HISTORIC AND DESIGN REVIEW COMMISSION

June 21, 2023

HDRC CASE NO: 2022-510
COMMON NAME: E Market at Hemisfair Park
LEGAL DESCRIPTION: NCB 13814 (HEMISFAIR - NORTHWEST QUADRANT), BLOCK 3 LOT 20
ZONING: D, H, RIO-3, Public Property
CITY COUNCIL DIST.: 1
DISTRICT: Hemisfair Historic District
APPLICANT: FitzGerald Associates Architects, PLLC
OWNER: PH Hemisfair LLC
TYPE OF WORK: Construction of a mixed-use structure, construction of a retail structure
APPLICATION RECEIVED: June 02, 2023
60-DAY REVIEW: August 01, 2023
CASE MANAGER: Edward Hall

1. Construct a 3-story retail structure to feature two levels above street level and 1 level at river level.
2. Construct a 10-story mixed-use structure to feature retail, residential units and an internal parking structure.

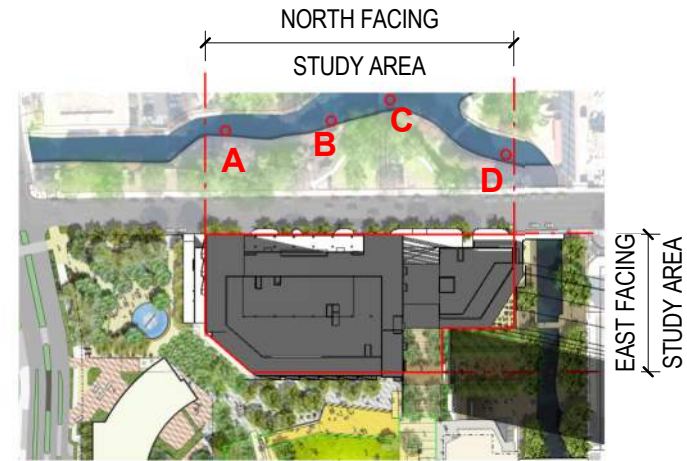
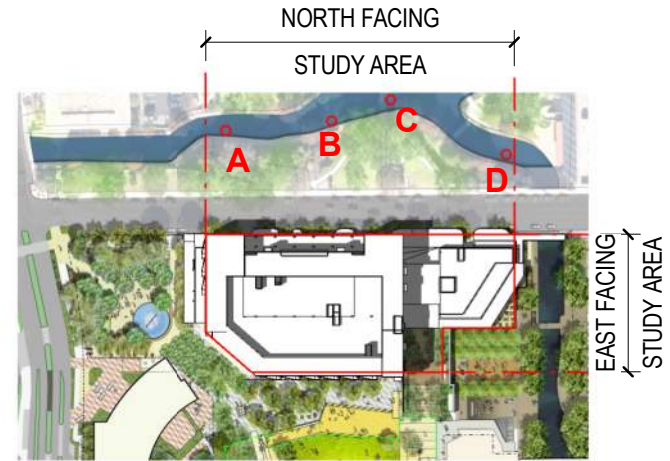
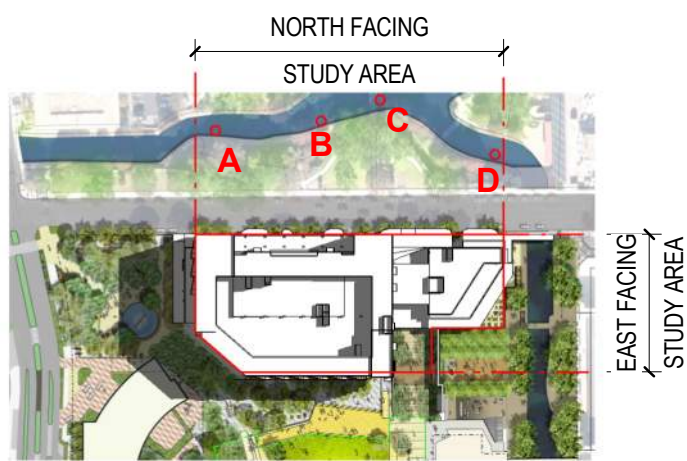
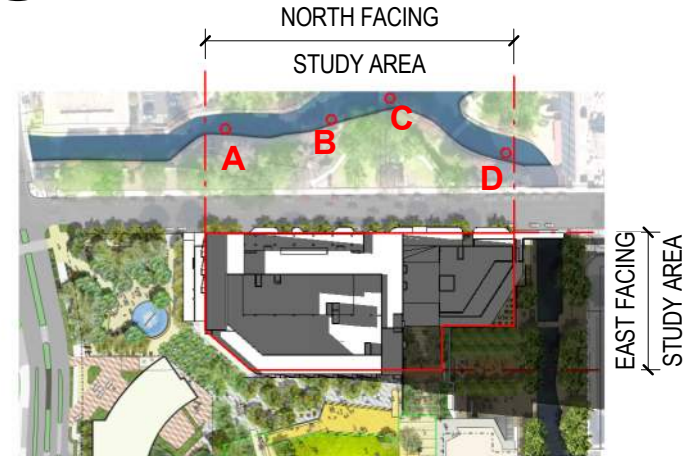
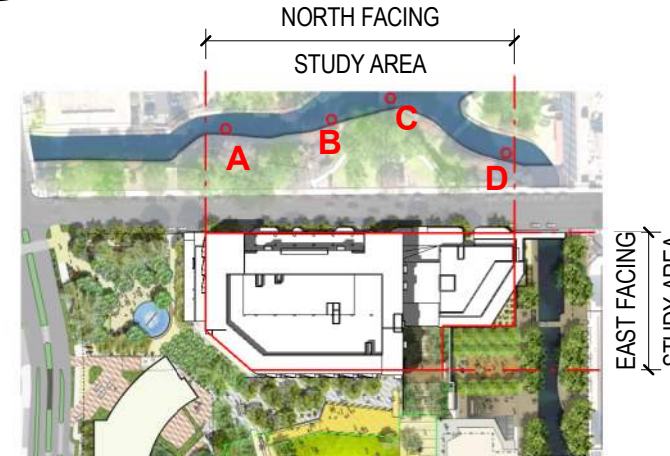
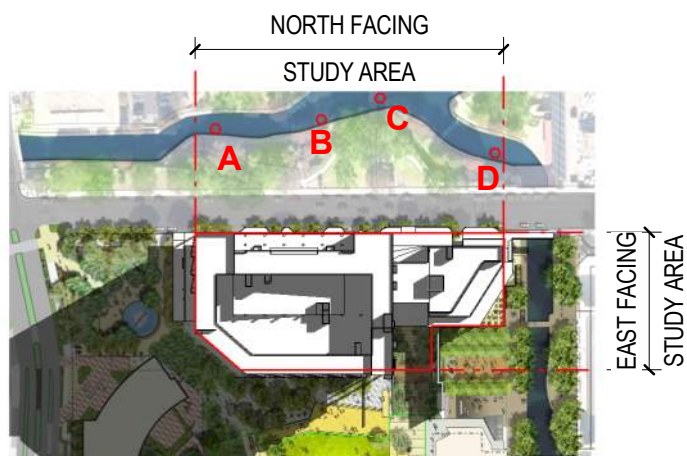
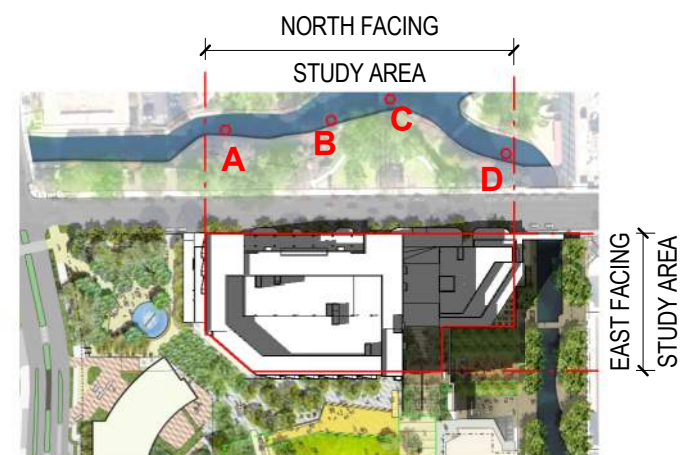
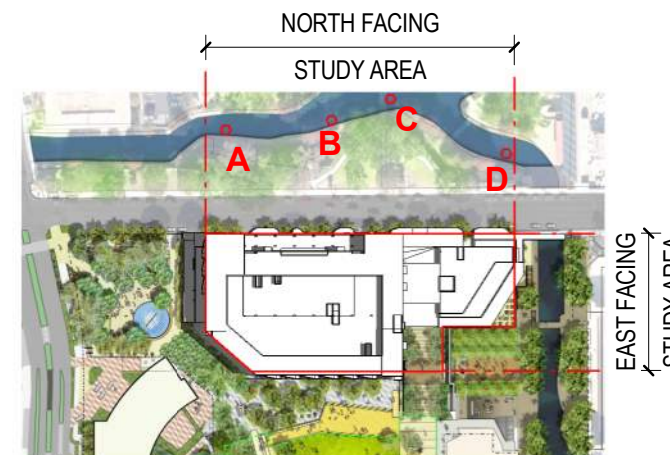
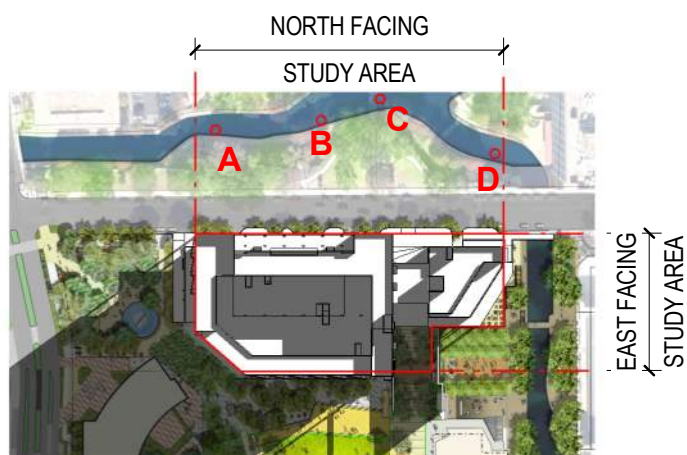
in direct sunlight from 6:34am to 2:04pm
- receive at least 7.5 hrs of sunlight

in direct sunlight from 6:34am to 2:04pm
- receive at least 7.5 hrs of sunlight

The proposed project meets the Solar Access requirement (**a minimum of 7.5 hours**) measured at the Summer Solstice per San Antonio's Unified Development Code (UDC) Sec. 35-673
